**Public Hearing for Conditional Use Permit
Amendment – Bobcat of Omaha**

RECOMMENDATION REPORT

CASE NUMBER: PCUP 18-0001

RE: Conditional Use Permit – Initial Review
Bobcat of Omaha CUP Amendment
8701 South 145th Street

SITE PLAN

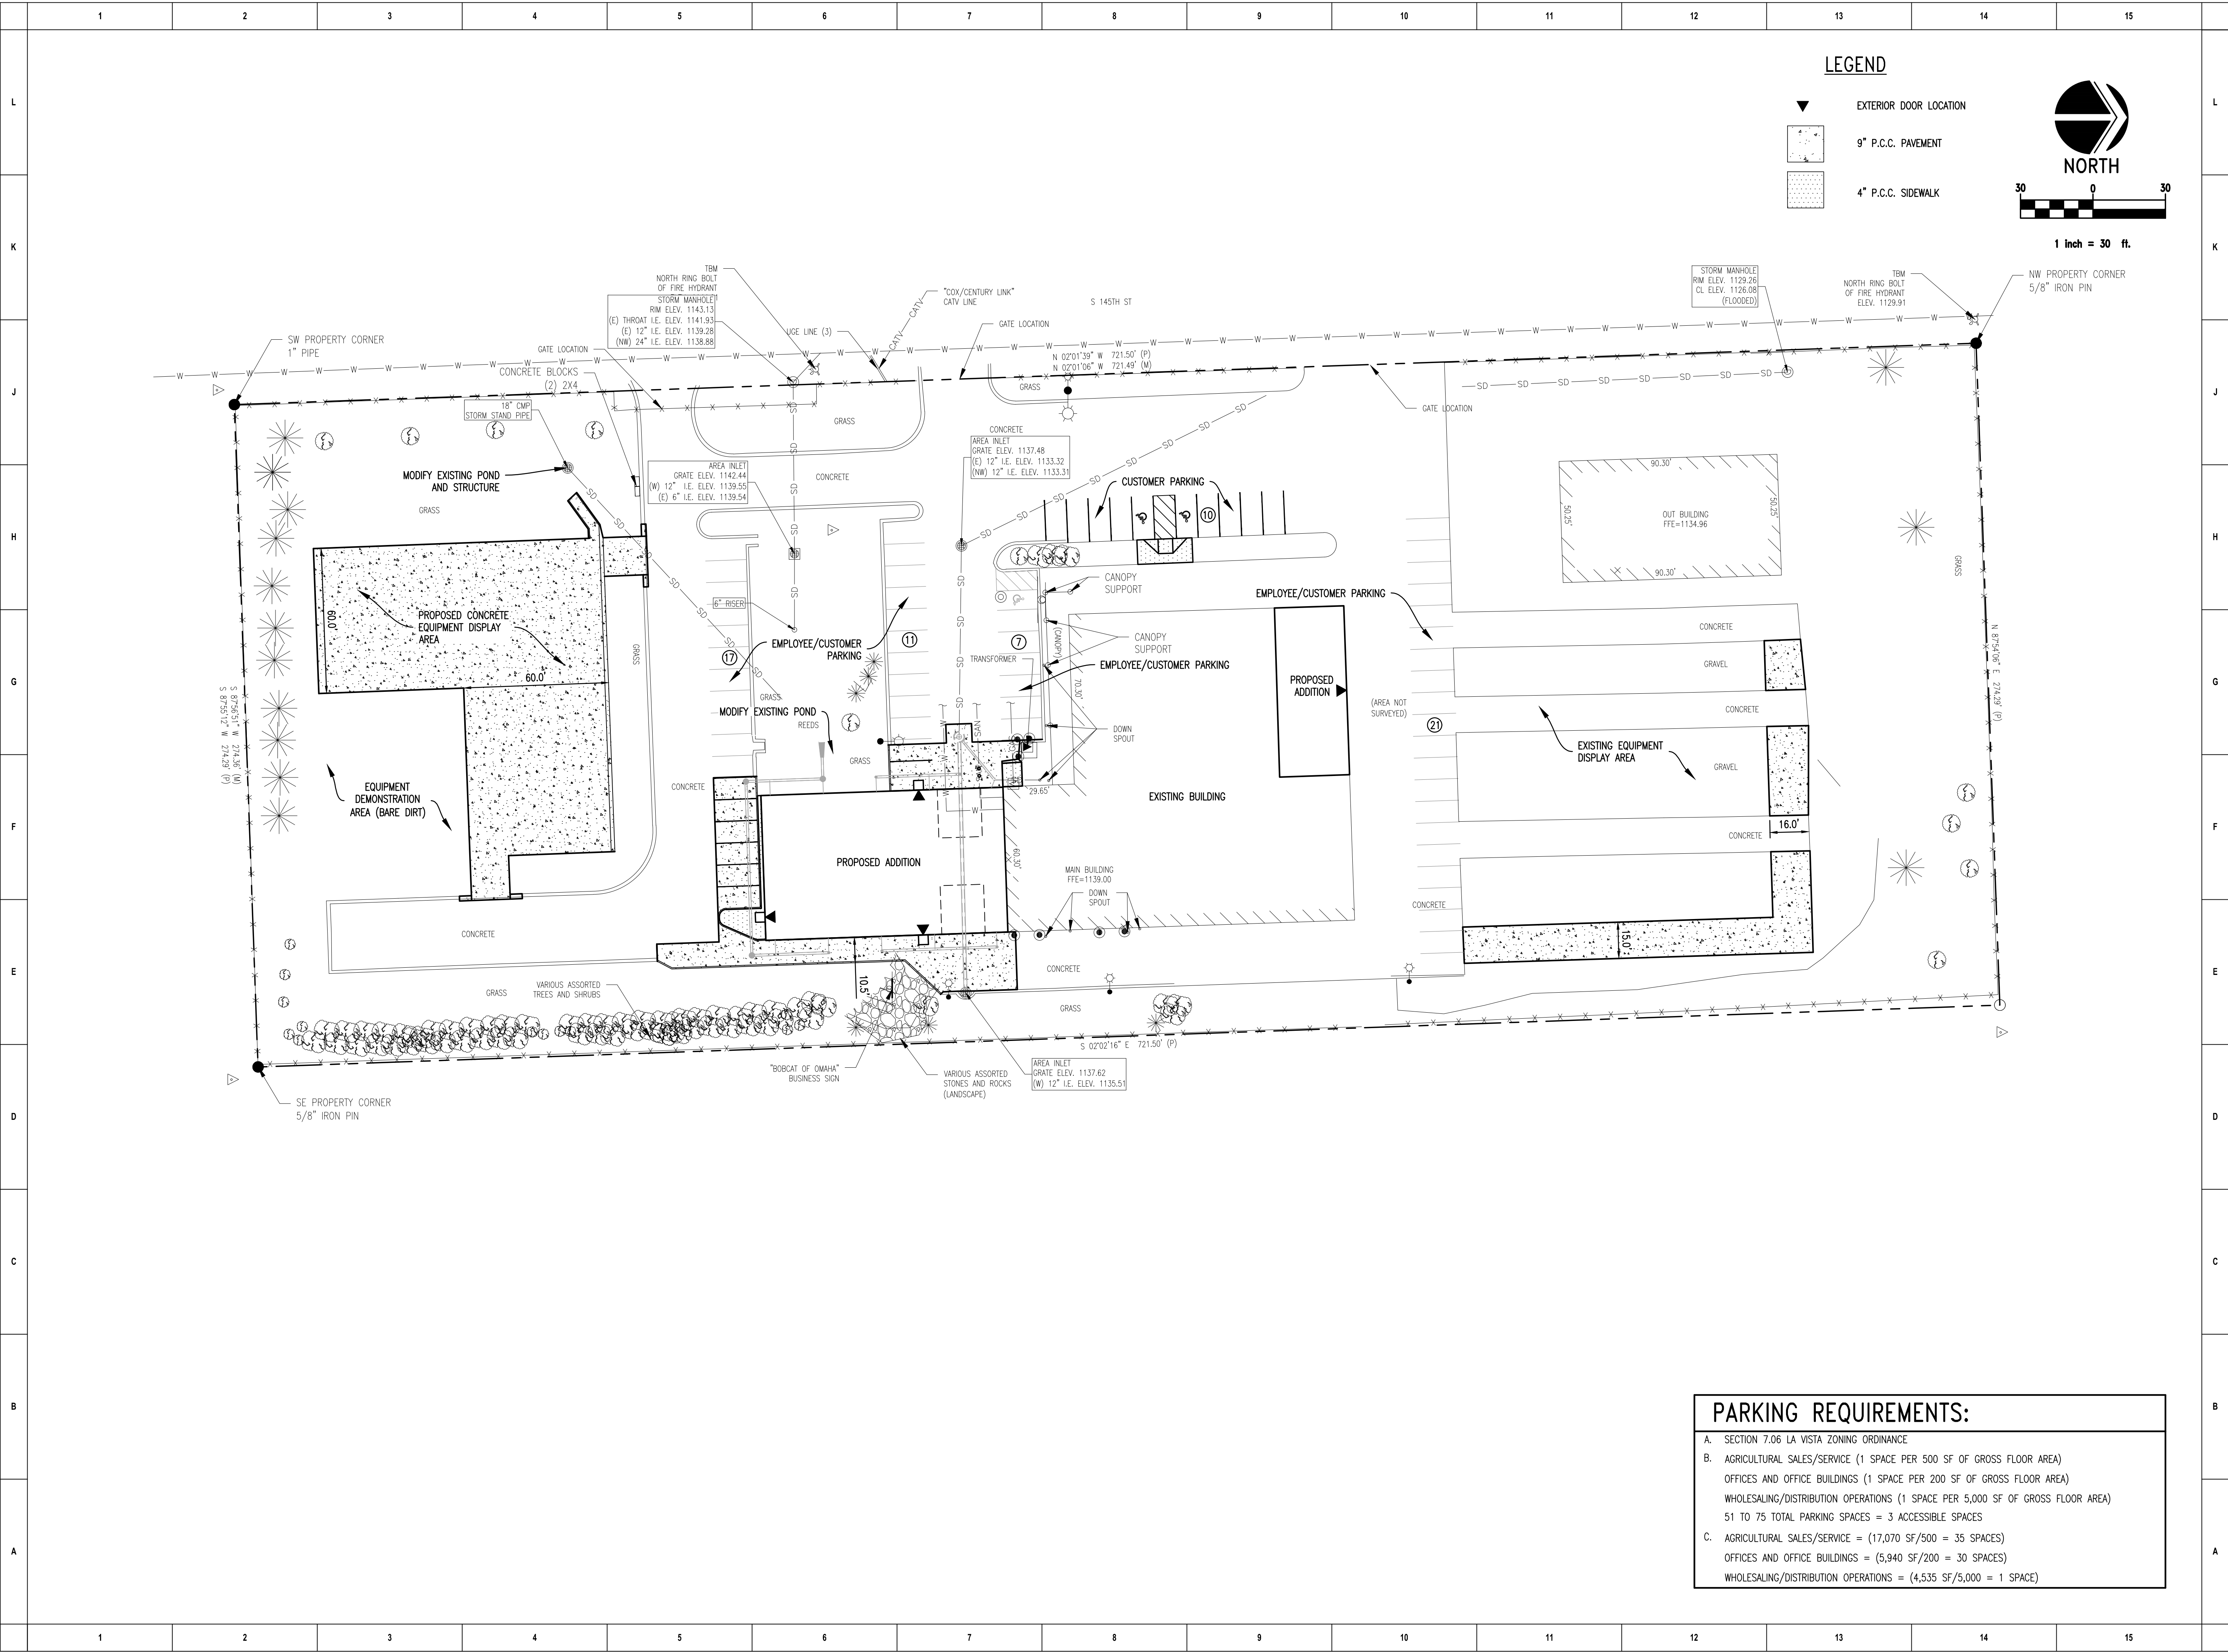
- 3. Relative to Article 6.05.04, the submitted site plan indicates modifications of existing water quality basins. These modifications will have to be accomplished through a PCSMP permit processed through the Permix website at the time of building permit and will need to demonstrate treatment of the first ½ inch of runoff and no increase in the 2-year peak flows above existing conditions. If the proposed pavement north of the existing building results in more than 5,000 SF of increased pervious area, it will be necessary to comply with post-construction storm water management requirements for those areas also.

- 4. The site plan indicates an equipment demonstration area along the norther

edge of the property that will be continually in a bare dirt condition. Such area should be kept to a minimum size to limit potential impacts from dust and erosion.

4. Relative to Article 6.05.04, the submitted site plan indicates modifications of existing water quality basins. These modifications will have to be accomplished through a PCSMP permit processed through the Permix website at the time of building permit and will need to demonstrate treatment of the first ½ inch of runoff and no increase in the 2-year peak flows above existing conditions. If the proposed pavement north of the existing building results in more than 5,000 SF of increased pervious area, it will be necessary to comply with post-construction storm water management requirements for those areas also.

5. In regards to Article 6.05.05, the site plan needs to identify which parking stalls are provided for employee and customer use versus equipment parking. Examination of an aerial photo indicates that the shown stalls north of the existing building are all used for equipment parking. Adequate on-site parking for the maximum number of employees and the maximum number of customers expected needs to be provided on site.
6. The site plan needs to indicate if there is going to be an equipment demonstration area that will be continually in a bare dirt condition. This relates to consideration of dust and erosion under Article 6.05.07. Such area, if proposed, should be kept to a minimum size.
